# Site Plan and Design Review Staff Report and Recommendation

**LAND USE REQUEST:** Site Plan and Design Review of a proposed 3,773-square-foot credit union building with drive-through and parking

**FILE NUMBER:** 311-18-000039-PLNG

**PROPERTY LOCATION:** 3532 Pacific Avenue

**C1.0**  
 JOB NUMBER: A17061.11

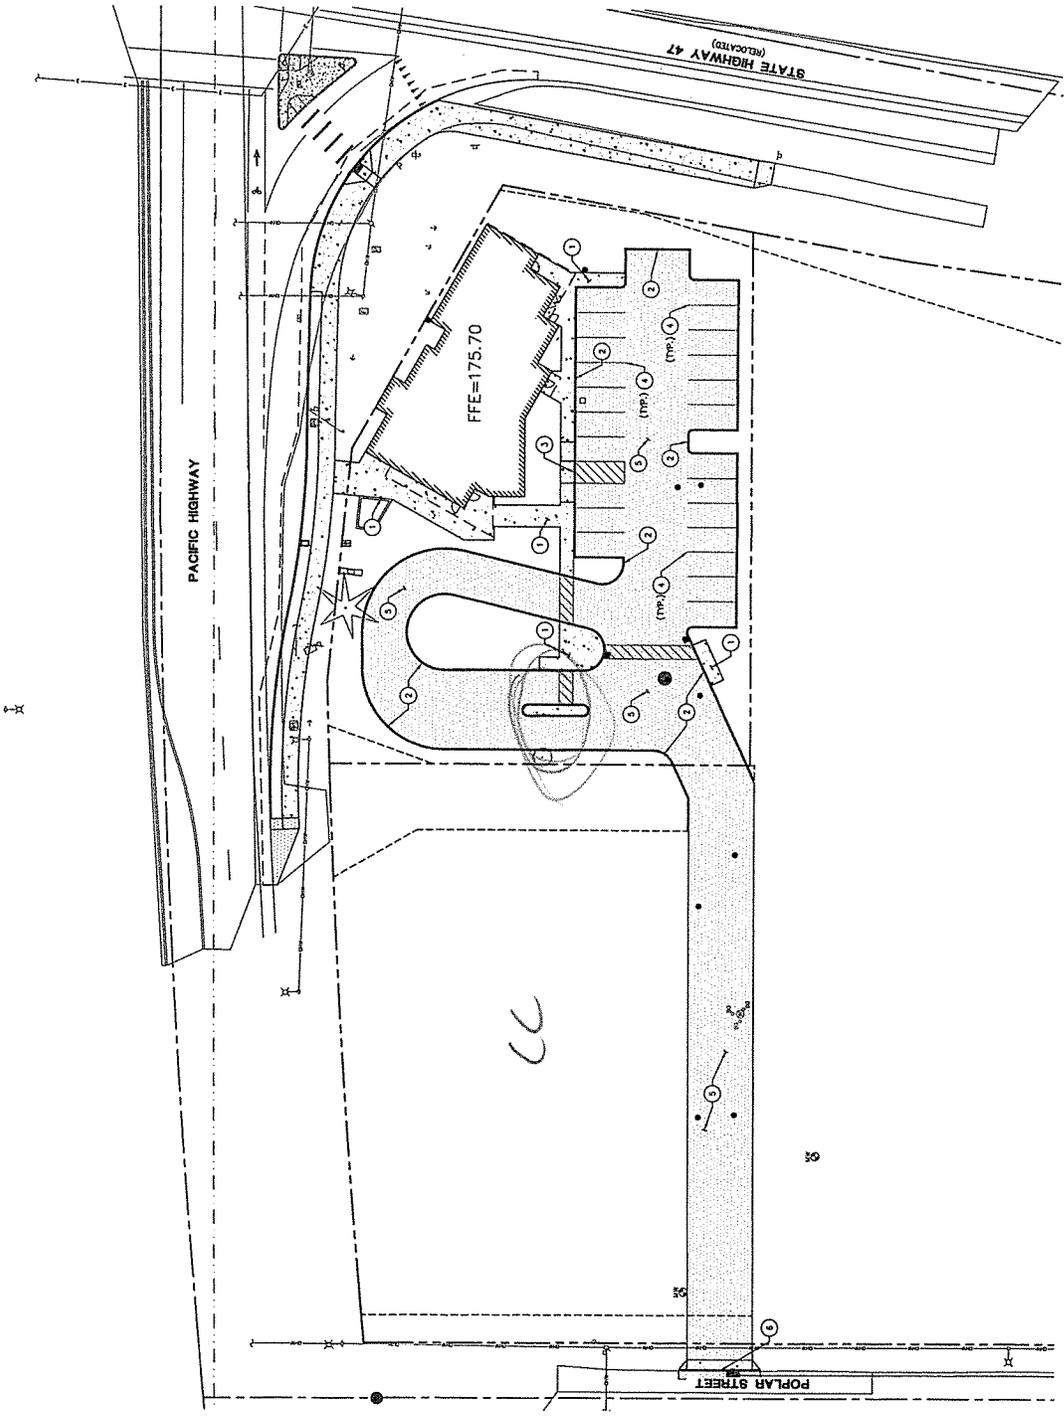
Access to the site would be via a driveway to Poplar Street over an existing easement. There would be no direct vehicular access to Pacific Avenue or to Hwy 47 (see Exhibit 1 Sheet C1.0 *Site Plan*).

A sidewalk is proposed to be installed in compliance with DC §10.8.620(A). No minimum dimension width is stipulated by code. Exhibit 1 Sheet A100 *Site Plan* indicates a 6-foot sidewalk would be constructed along Pacific Avenue to connect with the existing Hwy 47 bike path. FGC §151.002 *Sidewalk Specifications* requires that sidewalks comply with City Engineering standards for grades, locations, widths, materials and construction.

1 TREE PROTECTION PLAN  
 SCALE: 1/8"=1'-0"

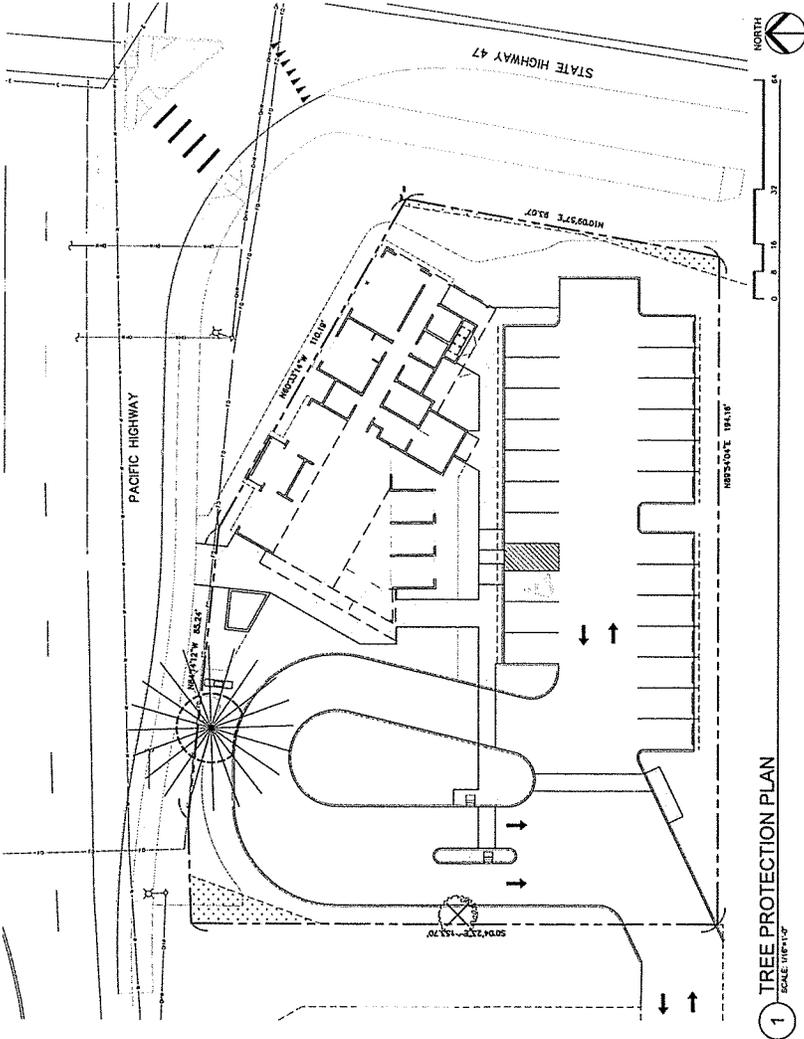
Depending on the ultimate site and right-of-way design, the existing Douglas fir tree may need to be removed for safety purposes, as the root zone on both the north and south sides of it might be compromised by the public improvements and ATM drive aisle respectively.

Finding: No sensitive natural resource areas, prominent topographic features, or sensitive natural resource areas exist on or adjacent to the site. This criterion does not apply to those features. There is a mature Douglas fir tree on-site near the north property line. While the intent is to preserve this tree, it may need to be removed because the installation of street improvements on the north and the ATM drive aisle on the south may adversely impact the root zone.

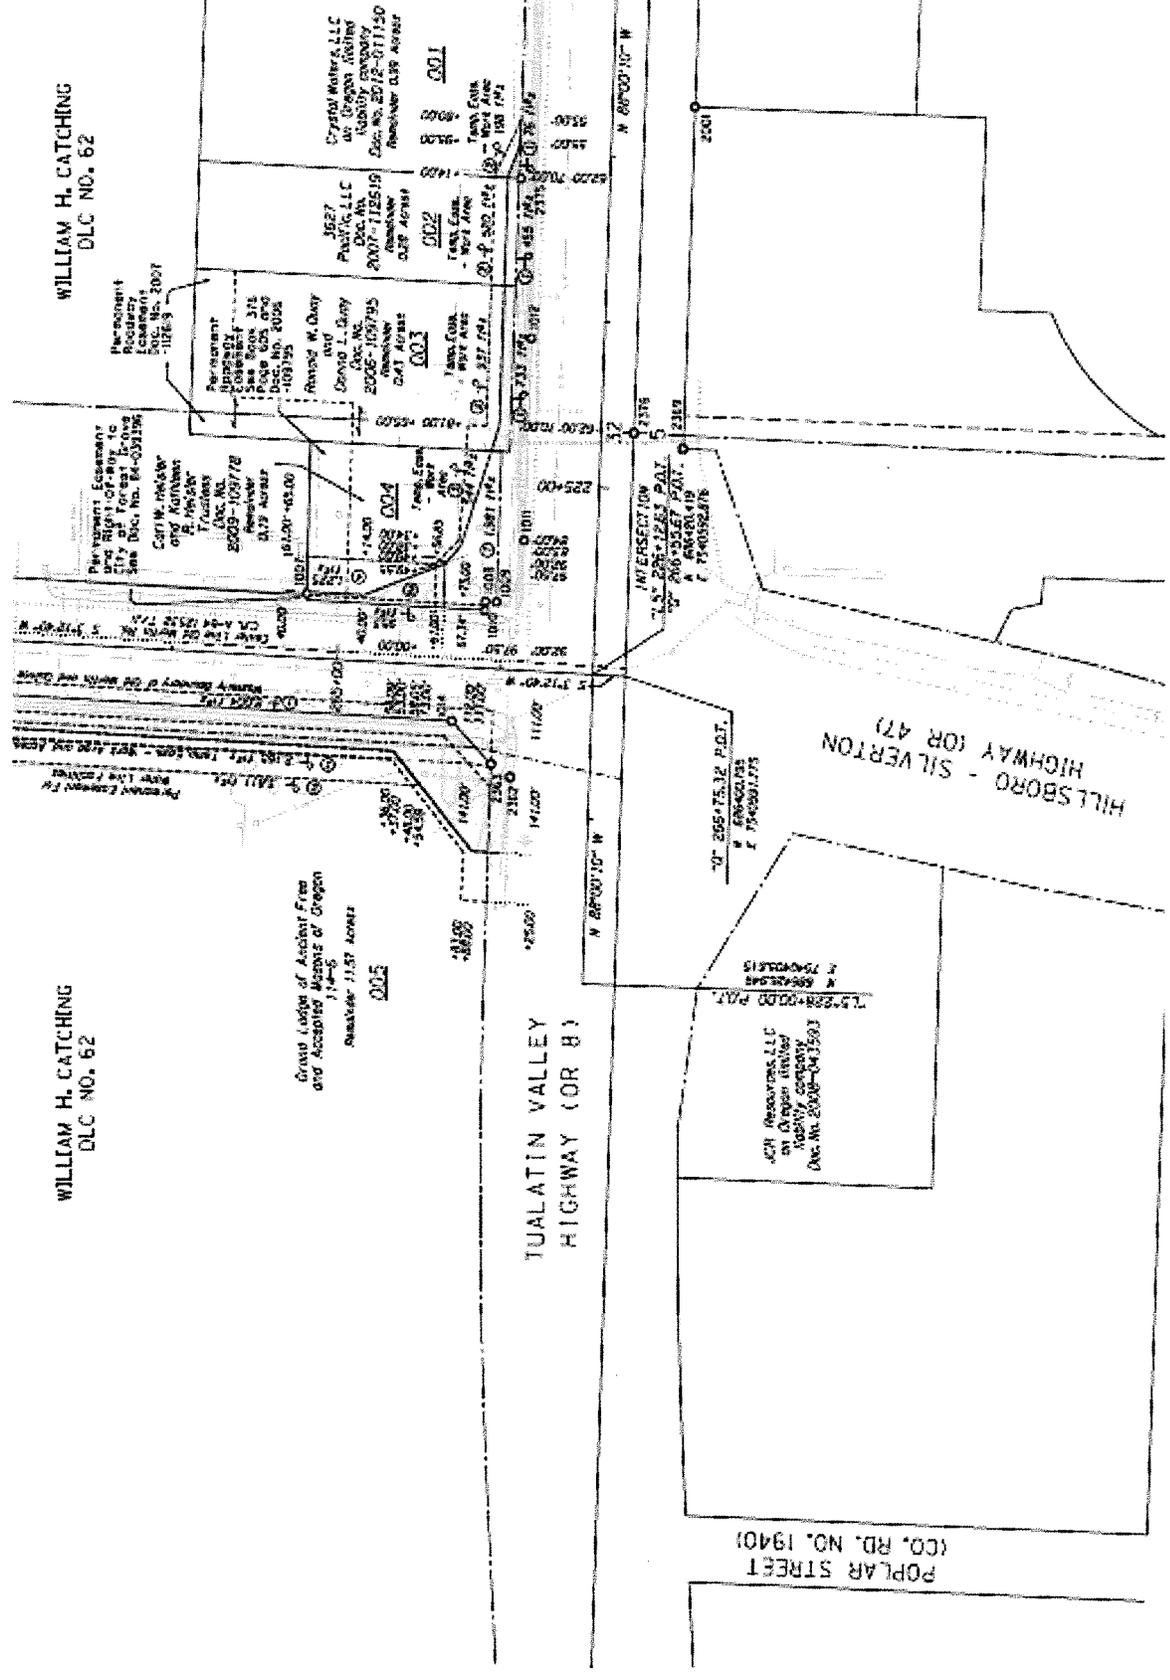
Please take a look at the attached figure. Since the RW line is not straight and we do not have records for Pacific Avenue we would have to do some estimation from the "assumed RW" centerline (middle of the 16-foot median). Based on the records from different projects, Pacific Ave existing cross-section would be:

Since the RW is varied we could state as the proposed RW measured from the middle of the median should be about 60.5 ft (if only 1 foot behind walk) to 61 ft (if 1.5 feet behind walk). This dimension would include the following:

- $\frac{1}{2}$  of the 16-ft median = 8 ft
- 2 12-foot lanes = 24 ft
- 6-foot bike lane = 6 ft
- 15-foot right turn lane = 15 ft PLUS the turning radius
- 0.5-foot curb = 0.5 ft
- 6-foot sidewalk = 6 ft
- 1 foot or 1.5 feet behind walk.
- If planter strip is required additional 4 feet - 8 feet would need to be included.
